ALERT SERVICE BULLETIN

TIN 505-21-20 PSL#541 PSL#591 20 February 2021 Revision A, 26 February 2021 Revision B, 3 March 2021 Revision C, 11 March 2021

MODEL AFFECTED: 505

SUBJECT: PILOT COLLECTIVE STICK AND GRIP ASSEMBLY M207-20M478-041 / -043 / -047, TERMINATING ACTION, INTRODUCTION OF.

FIGURE 1 – Pilot Collective Stick and Jackshaft Assembly

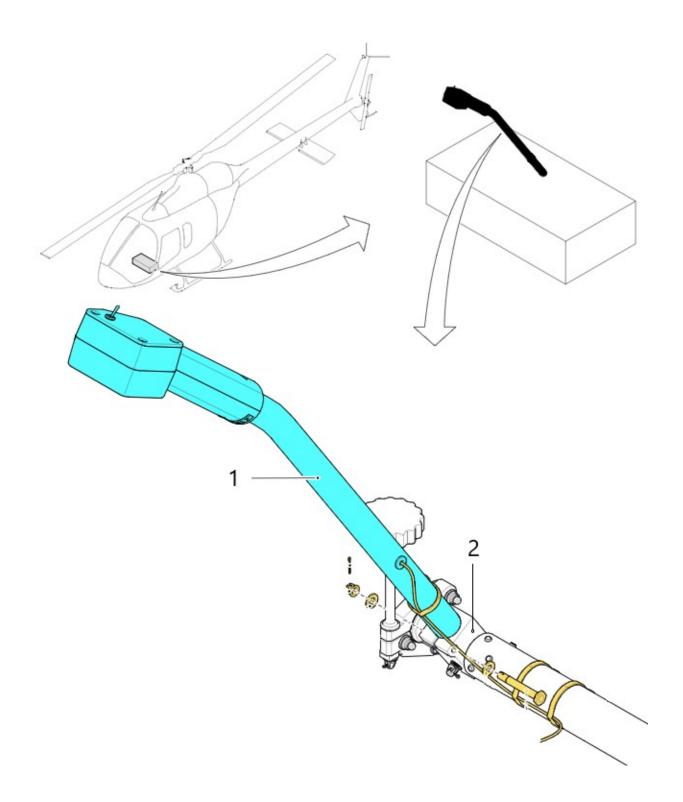
- 3. Remove pilot collective stick and grip assembly (1, Figure 1) (<u>DMC-505-A-67-11-01-00A-520A-A</u>) from jackshaft assembly (2).
- 4. Clean pilot collective stick and grip assembly at areas identified (Figure 2) with a clean cloth (C-516) moistened with dry-cleaning solvent (C-304) or equivalent.

- 1. Prepare the helicopter for maintenance.
- 2. Remove pilot collective stick and grip assembly (1, Figure 1) (<u>DMC-505-A-67-11-01-00A-520A-A</u>) from jackshaft assembly (2).

FIGURE 2 - Inspect Complete Circumference in Areas Identified

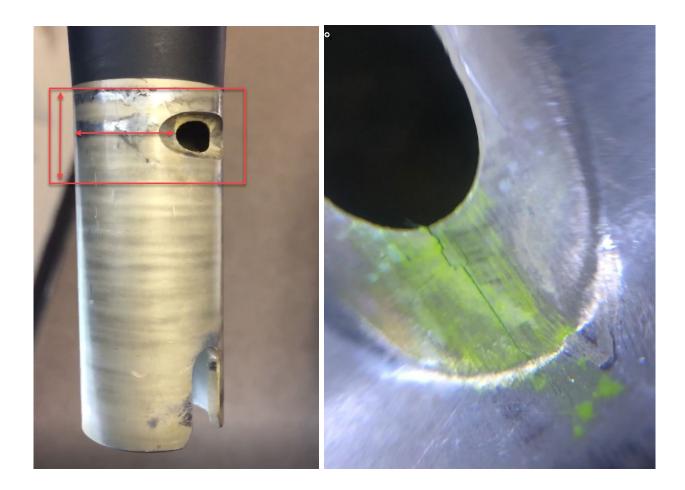
- 5. Perform a fluorescent penetrant inspection (BHT-ALL-SPM, Chapter 6) in the area of complete circumference of the pilot collective stick and grip assembly at the areas identified (Figure 2). Level I Special trained individual is qualified to perform task and acceptance.

- a. If a crack is confirmed following the fluorescent penetrant inspection, the pilot collective stick and grip assembly is considered unserviceable as is. Report findings with pictures to Product Support Engineering at productsupport@bellflight.com before proceeding. Make sure that the following is in the subject line of the e-mail:

- 1. Service directive number: 505-21-20 Revision B
 - 2. Helicopter serial number
 - 3. Operator name
 - 4. Total time in service
 - b. If there is no crack identified following the fluorescent penetrant inspection, go to step 6.

Figure 2 - Pilot Stick Tube, Collective P/N M207-20M301-101

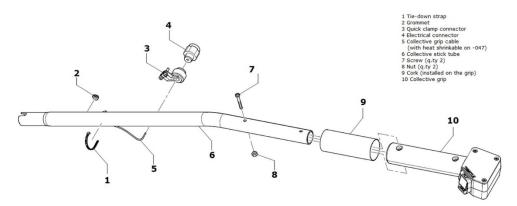
The present document provides the procedure to remove the Pilot Stick Tube, Collective P/N M207-20M301-101, installed on the Collective stick and grip assembly P/N M207-20M478-043 or M207-20M478-047 and replace it with the Pilot Collective Stick Tube Assembly P/N M207-20M301-043, which includes an improved Pilot Stick Tube, Collective P/N M207-20M301-105 with previously installed Internal doubler P/N M207-20M308-101.

Figure 24 - Tie-down strap position and cable orientation

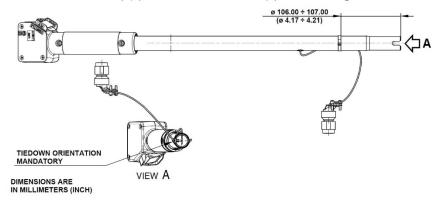
MAKE SURE THAT CABLE ORIENTATION IS AS SHOWN IN VIEW **A** OF Figure 24. 30. Install tie-down strap (1) to lock cable to stick tube (6) as shown in Figure 24.
